FURCO
Company

QUALITY ASSURANCE
PROGRAM

REPORT NO E-77-32

PLANT: Midland UNIT 1 &
SUBJECT OF AUDIT: Soil Placement
Records

Figure 3

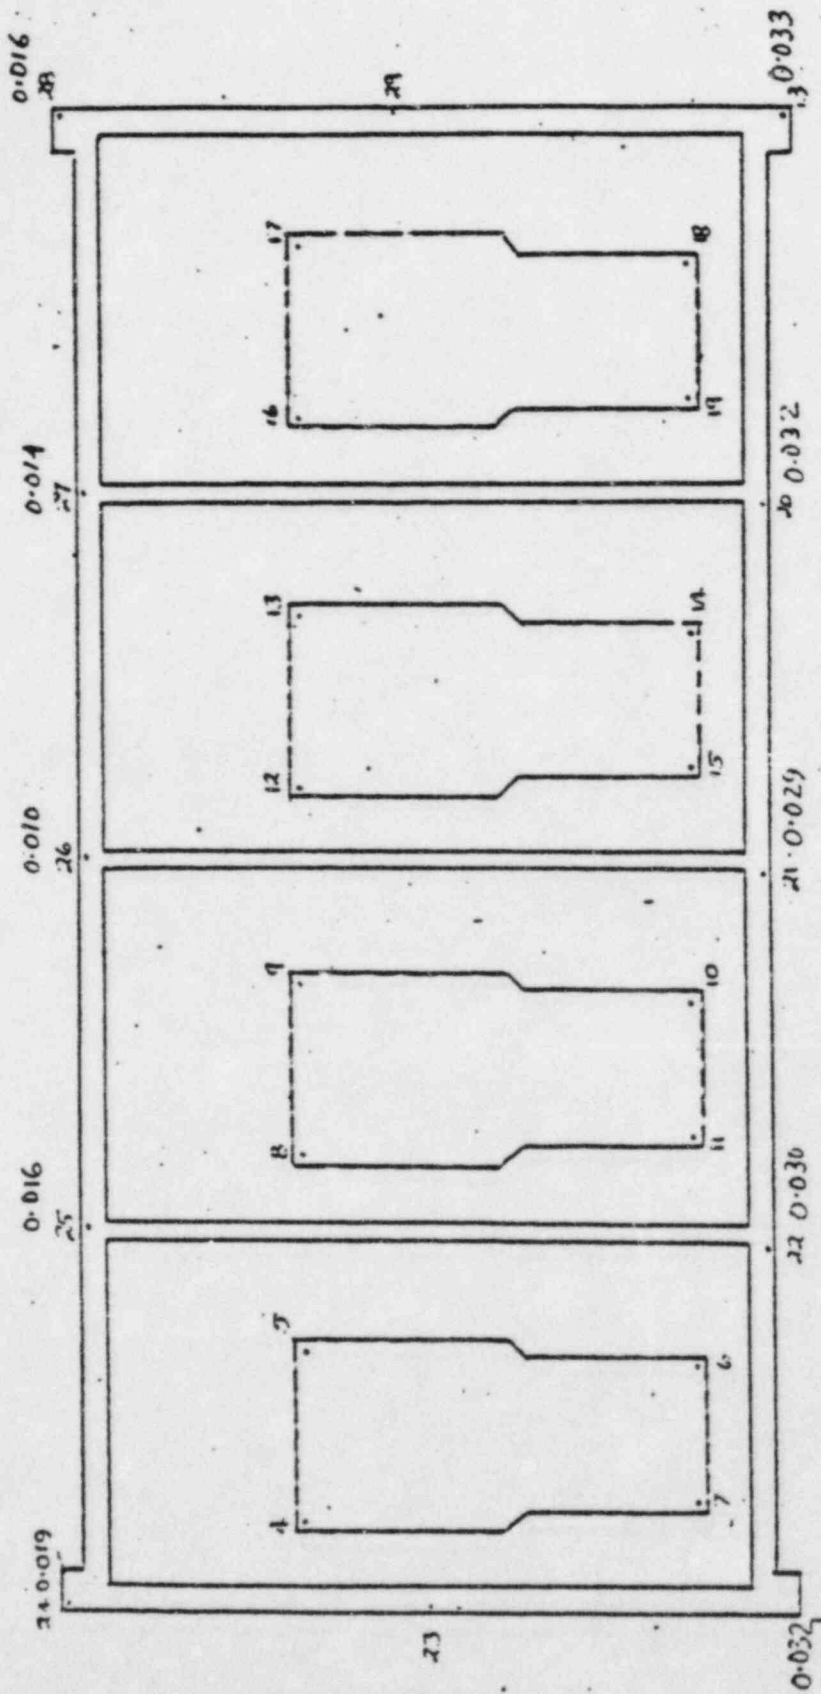
1. BA 61 through 64 data indicates that those four points on the mezzanine floor are settling in a plane (i.e. 3 points define a plane, and the fourth lies on it). Referring to the set of 8½" x 11" sheets handed out during a meeting in early June, the contour orientation defining this plane is between the orientations on the fifth sheet (attached here as Fig. 3) and the sixth sheet (Fig. 4). Hence orientation appears consistent.

Contours appear E-W.

Figure 6

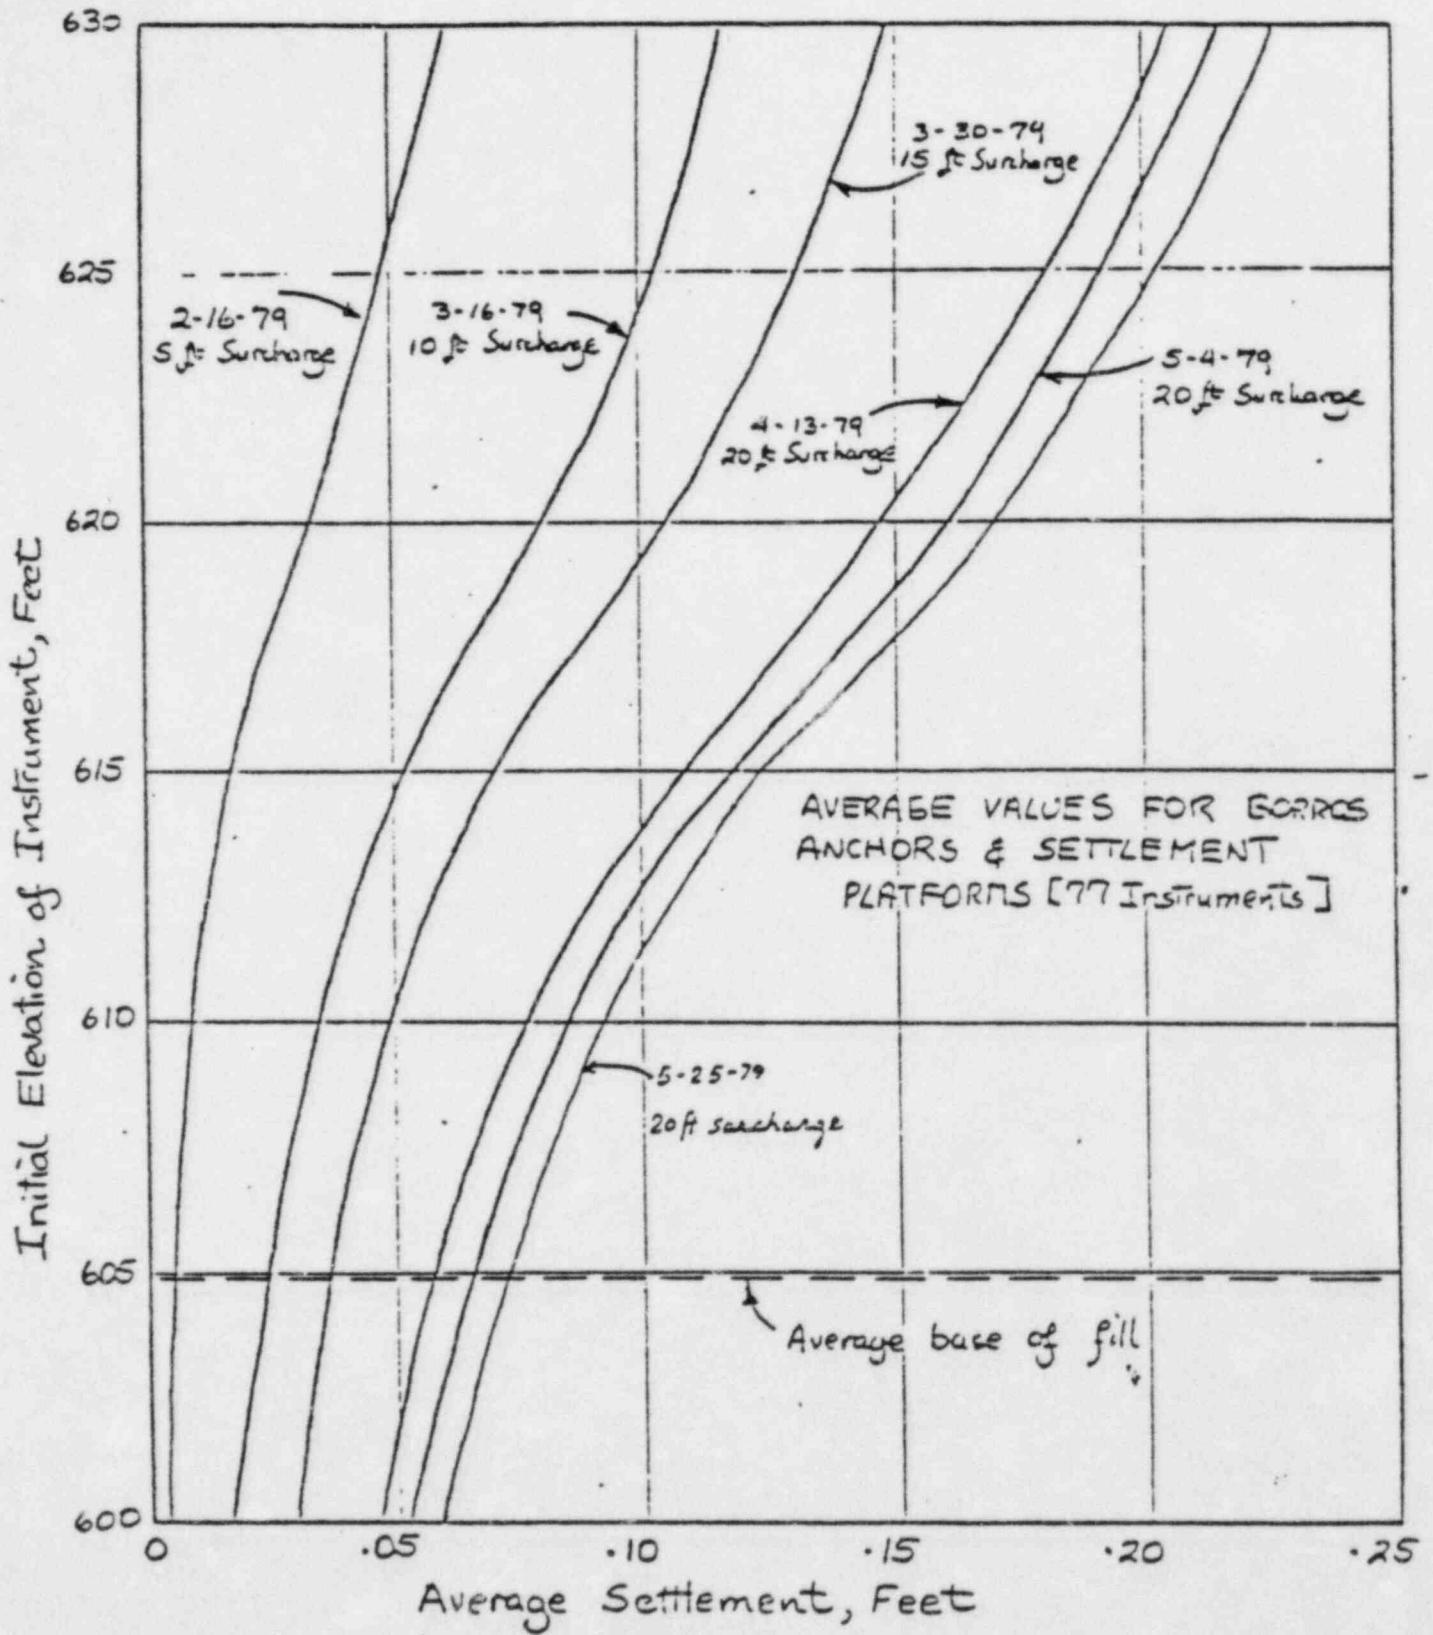
3. Fig. 2 indicates the same type of scatter noted on the optical survey Borros anchor and settlement platform plots (Eleventh sheet of your June meeting handout, here as Fig. 6) and I recommend that you work with these data in cluster groups, as you did to derive the twelfth sheet (Fig. 7). Fig. 2 shows, as it should, generally lesser settlement with depth and generally lesser settlement towards the NW zone. It also shows continuing settlement below elev. 585 ft. I believe it is realistic to add the four BA 61 through 64 points (0.230, 0.195, 0.140, 0.095 inches) on Fig. 2 at the elevation of the bottom of the footings (628 ft ?), i.e. to assume no significant length change between footings and mezzanine floor.
